Nant Mithil Energy Park, Powys.
PEDW DNS Application Ref: DNS CAS-01907-D7Q6Z1.

CPRW-RE-think Chapter 9 on

Aviation & Telecommunications

Prepared by: Jeremy Andrews, qualified communications engineer with over 30 years experience in radio frequency networks and planning.

Figure 1: Map of Radnor Forest showing 100% of area has lowest levels of light

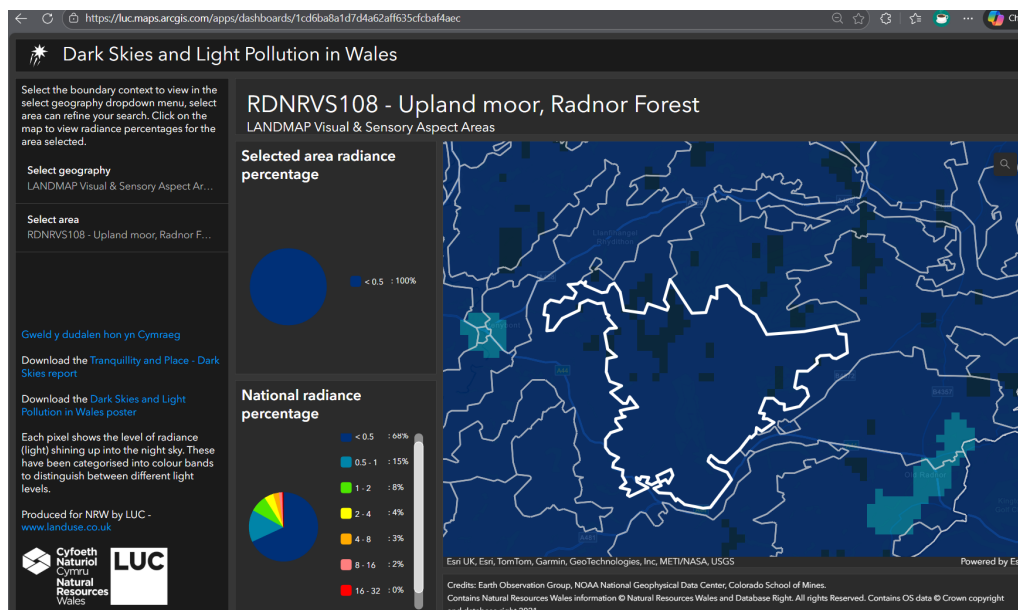
- 6.1. App. 12.1 shows that to address some of the guidance and rules from the MoD and the CAA some turbines will need lights on top.
- 6.2. The wind farm is in a location with dark skies as shown on this dark sky map figure 1.

- 6.3. The lighting on the top of the wind turbines will result in this region no longer being a dark sky. Interest in the skies has increased over the recent years, with many local residents enjoying observing comets, distant stars and the northern lights. The lights on the proposed wind turbines will mean that local residents will no longer be able to enjoy this area for its dark skies. The nearby observatory near Knighton will be impacted by the lights when observing the night sky in the direction of the proposed wind farm. We do not believe that the Applicant has fully considered the impact to local residents and organisations.

Figure 2: DAB Radio coverage prediction for Mid and West Wales

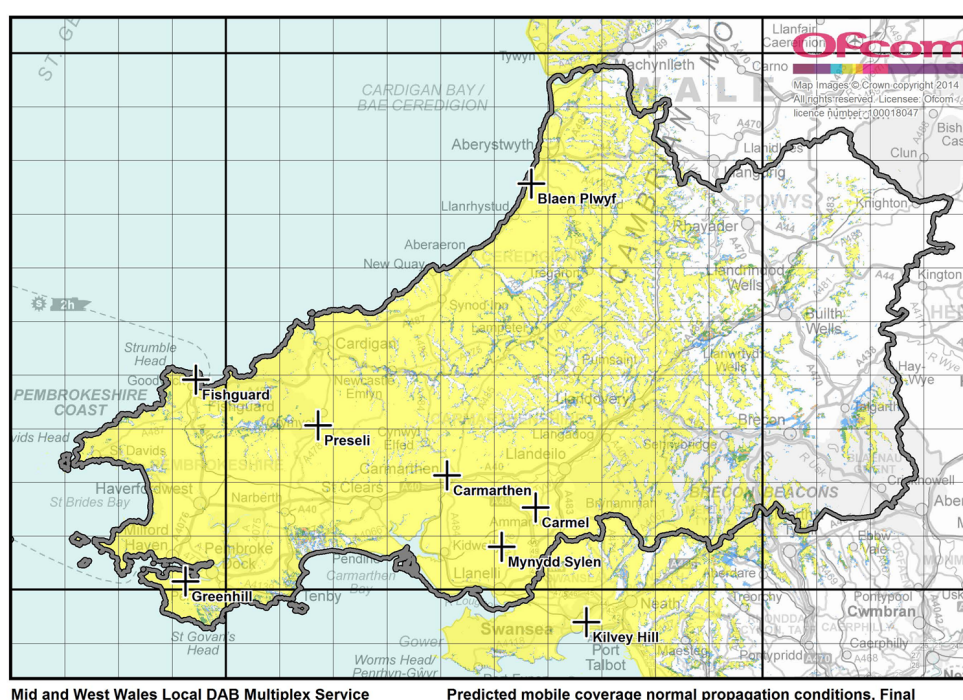
survey to understand the potential for interference to television and radio reception, and consideration is made for a planning condition requiring the developer to mitigate the impact of any degradation of television and radio reception caused by tall buildings & wind turbines, similar to many other wind turbine and wind farm schemes.” Wind turbines can affect the DAB Radio and Digital TV Services by blocking, diffracting and reflecting the RF signals. For the domestic user this can result in additional signal loss and data errors which can result in loss of signal. There is no reception survey of the impact to DAB Coverage. We have undertaken a desktop assessment using OFCOM published data for DAB Radio coverage (figure 2).

Figure 3: Predicted DAB Radio Coverage from the Llandrindod Wells Transmitter

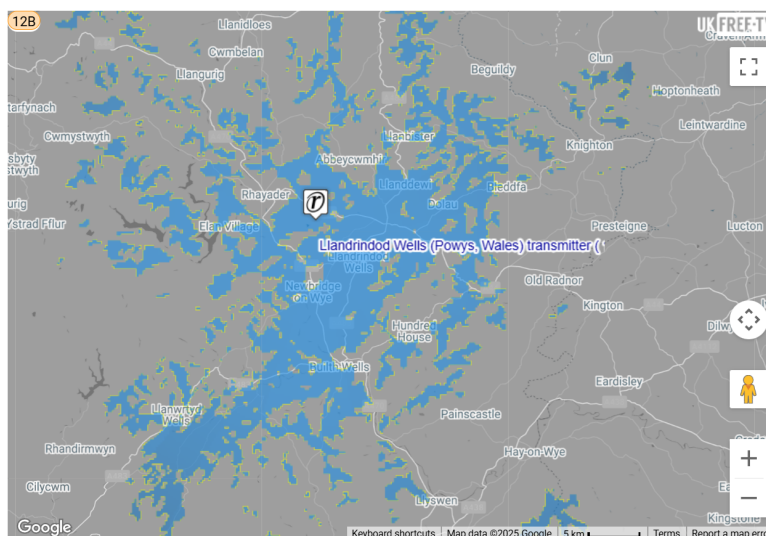
- 7.2. As it can be seen from the existing propagation coverage map for DAB Radio in Mid and West Wales (figure 3), the region where the wind farm is proposed in the north east of this map is already showing as a poor coverage area. A repeater for the DAB Radio signals is located on a transmitter tower close to Llandrindod Wells.
- 7.3. A desktop predicted coverage prediction for TV Signals from the Llandrindod Wells TV transmitter (figure 4) shows that the residents to the west of the location of the proposed wind farm are already experiencing patchy TV coverage. Some residents close to New Radnor have confirmed this to us. We are concerned that the additional potential degradation of TV and DAB Radio signals to the residents close to the proposed wind farm has not been taken into consideration.
